# An introduction of Three-Dimensional Precipitation Particles Imager (3D-PPI)

## Response to the reviewers

[Figure C.1. Top view of wind speed distribution in the simulated wind field. 3D-PPI facing 10 m/s wind \(a\); back facing 10 m/s wind \(b\); side facing 10 m/s wind \(c\). The color gradient represents wind speed, with the observation volume indicated in \(a\).](#)

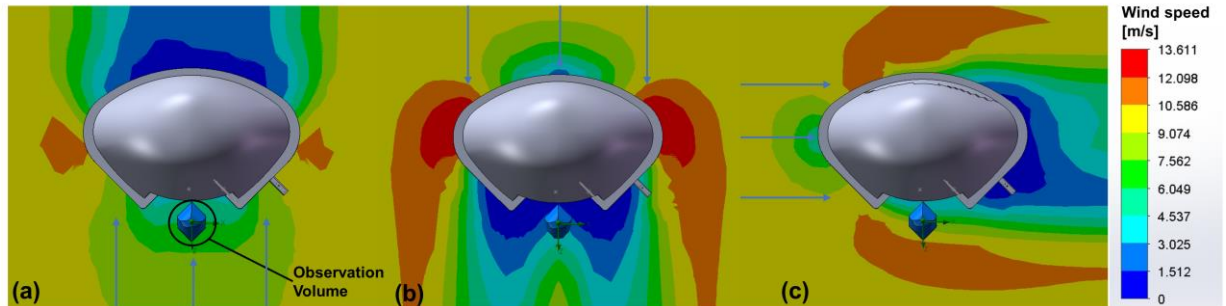
*2. Given that the sampling volume is so close to the instrument housing, how will wind flow affect the representativeness of the measurements (e.g., increasing or decreasing the collection efficiency of the sampling volume)? While I understand that a full engineering analysis of the wind effects (similar to what was presented in Fig 3 of Newman et al. 2009, <https://doi.org/10.1175/2008JTECHA1148.1>) may be outside the scope of this paper, some analysis that compares the 3D-PPI to the PARSEVAL with the wind coming from certain directions relative to the camera pointing direction might help give some insight into how well the instrument handles these conditions.*

Thanks for your comments. We have added the wind field simulation in the Appendix C.

### Appendix C: Wind field simulation

To determine the optimal orientation of the 3D-PPI installation (mainly considering the relationship with the prevailing wind direction), we conducted wind field simulations using Solid flow simulation software. The simulation results are shown in Fig. B.1.

When the 3D-PPI is facing the wind (Fig.B.1a), the observation volume experiences an average wind speed of approximately 6.0 m/s. Besides, turbulence may occur within the observation volume. When the 3D-PPI is back facing the wind (Fig. C.1b), the average wind speed in the observation volume is only about 3.5 m/s, which is obviously due to the shielding of the wind by the instrument. When the 3D-PPI is side facing the wind (Fig. B.1c), the observation volume shows an average wind speed of about 8.5 m/s, exhibiting the smallest difference from 10m/s, compared to the other two situations. However, part of the observation volume close to the instrument is still shielded by the housing, which to some extent also affects the representativeness of the wind field, and subsequent consideration will need to be given to improving the instrument design to solve this problem.

In addition to 10m/s, we also simulated 5m/s, 20m/s, and 40m/s wind speed fields, and all of them got the consistent conclusion that the wind speed in the observation volume is closest to the simulated wind speed when the instrument is side facing the prevailing wind direction. Therefore, the instrument should be installed sideways to the dominant wind direction in the area, to minimize the disturbance of the instrument to the natural wind field. The prevailing wind direction in the area is west, so the 3D-PPI is installed facing towards the south.

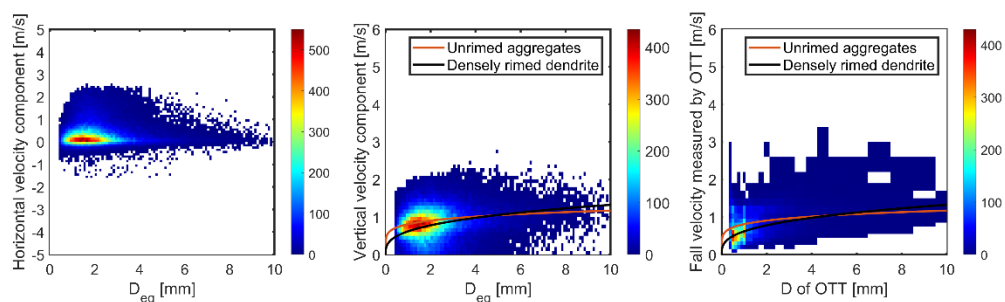
13.Lines 390 – 391: *Is the 200 pixels interval purely in the vertical or is that include the horizontal component of the distance as well. If that includes the horizontal distance, it might be worth noting that this means the instrument will have difficulty producing accurate particle fall speeds at high cross-camera-view wind speeds (which isn't a problem, but is good to know for anyone performing an analysis of the data).*

Thank you for your comments. The 200 pixels interval represents a purely vertical speed measurement. The horizontal velocity of snowflakes is heavily influenced by wind speed, which can exceed 10 m/s, while the vertical velocity typically does not exceed 4 m/s. We appreciate your reminder regarding the 8 m/s speed; indeed, it is somewhat higher. We have reformulated that statement to reflect that the maximum vertical speed is 4 m/s:

(ii) the pixel coordinates in the particle images are similar (the falling velocity of the snowflake is generally not more than ~~48~~4 m/s, so the interval between neighboring snowflakes is not more than ~~100~~200 pixels);
